***EX PARTE* REEXAMINATION COMMUNICATION TRANSMITTAL FORM**

Notice of Intent to Issue Ex Parte Reexamination Certificate	Control No. 90/019,119	Patent Under Reexamination 8223117	
	Examiner Colin LaRose	Art Unit 3992	AIA Status No

NOTICE OF INTENT TO ISSUE A REEXAMINATION CERTIFICATE (NIRC)
(EX PARTE REEXAMINATION OF U.S. 8,223,117)

The Instant Proceeding is an *ex parte* reexamination of U.S. Patent No. 8,223,117 (“Patent Under Reexamination” or “’117 Patent”) titled “METHOD AND APPARATUS TO CONTROL DISPLAY BRIGHTNESS WITH AMBIENT LIGHT CONDITIONS.” The Patent Under Reexamination was filed on December 17, 2008 (“Non-Provisional Filing Date”) and assigned by the Office non-provisional U.S. patent application control number 12/336,990 (“Non-Provisional Application”) and issued on July 17, 2012 with claims 1-20 (“Originally Patented Claims”).

FIG. 2 of '117 Patent (annotated by Examiner)

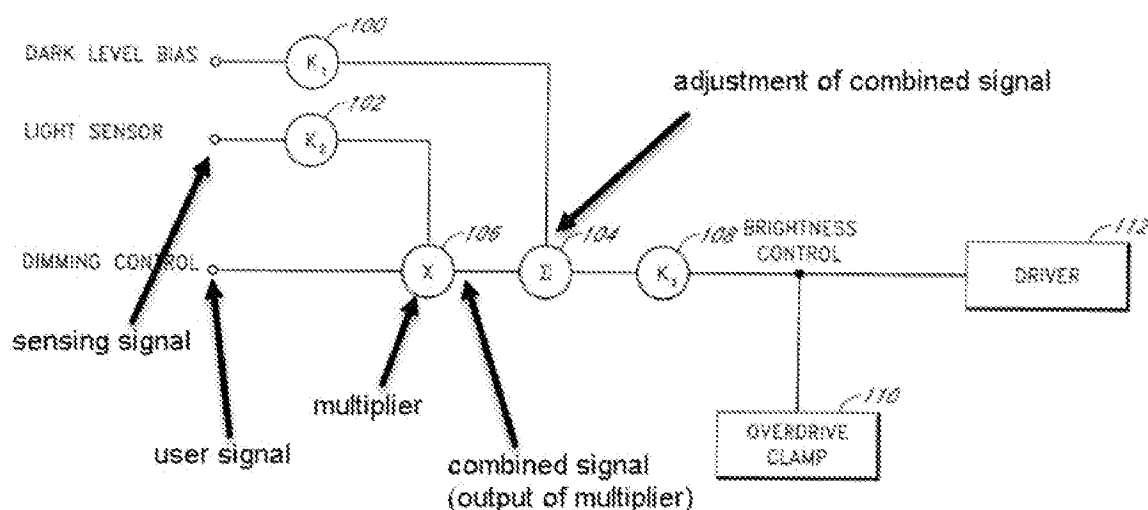
As recited in claim 1, the multiplier uses the user signal and the sensing signal to produce a combined signal. The dark level bias then adjusts the “combined signal,” for example via addition, as illustrated in FIG. 2 –

contrast, the embodiment of FIG. 2 illustrates the combined signal being generated as a linear combination of only the sensing signal and the user signal; after the combined signal has been generated, it is adjusted by the dark level bias at adder 104.

The plain language of claim 1 has therefore limited the scope of the claim to the embodiment of FIG. 2 in which the combined signal is generated and then adjusted by the dark level bias. Claim 1 is considered to require a sequential order of functional operations in relation to the configuration of the claimed circuit:

FIG. 1 of '117 Patent (annotated by Examiner)

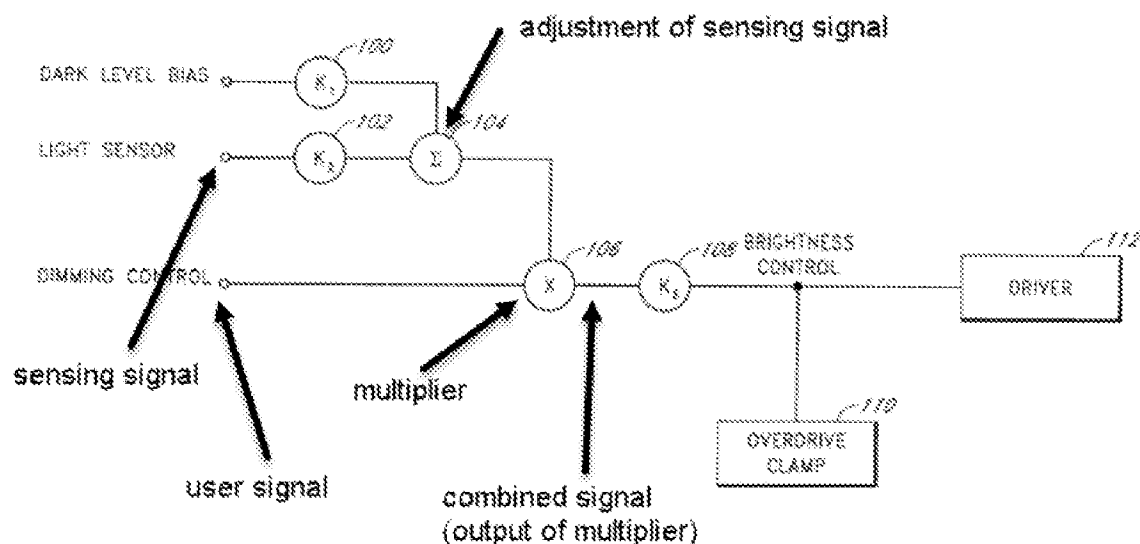
FIG. 1, however, illustrates a different embodiment in which the dark level bias is used to adjust the *sensing signal*, rather than the combined signal. As shown in FIG. 1 (see annotated figure below), a scaled dark level bias is added to a scaled sensing signal at adder 104 to produce an adjusted sensing signal (i.e., a scaled sensing signal that has been adjusted by a scaled dark level bias). The adjusted sensing signal is then multiplied by the user signal at multiplier 106 to produce the combined signal, which is shown as the output of the multiplier.

Accordingly, FIG. 1 illustrates an embodiment where the combined signal is *not* adjusted by the dark level bias. In FIG. 1, a scaled dark level bias is added to the sensing signal and then the sum is applied as an input to the multiplier 106 for the *generation* of the combined signal, as opposed to the dark level bias being used for the *adjustment* of the combined signal after the combined signal has been generated by the multiplier.

In FIG. 1, the combined signal is generated as a linear combination of the dark level bias, the sensing signal, and the user signal; thereafter, it is not adjusted by the dark level bias. In

Examiner respectfully disagrees with the above assertion inasmuch as the output of the multiplier (i.e., the combined signal) is, by all accounts, not “modified” by the dark level bias in FIG. 1. As explained and shown above, the dark level bias of FIG. 1 is used as one of three inputs for the purposes of generating the combined signal, rather than being used to adjust (“modify”) the combined signal after it has been generated.

It is unclear how a signal can be “adjusted” before it has been created in the first instance. The usage of the dark level bias shown in FIG. 1 constitutes an adjustment to a value (“sensing signal”) used as input for generating the combined signal. The dark level bias contributes to the creation of the combined signal rather than a post-processing adjustment of a generated combined signal. Before the multiplication operation 106 in FIG. 1 is executed, the combined signal does not exist (i.e., it has yet to be generated). Logically, one cannot adjust (“modify”) something that does not exist and has yet to be created.
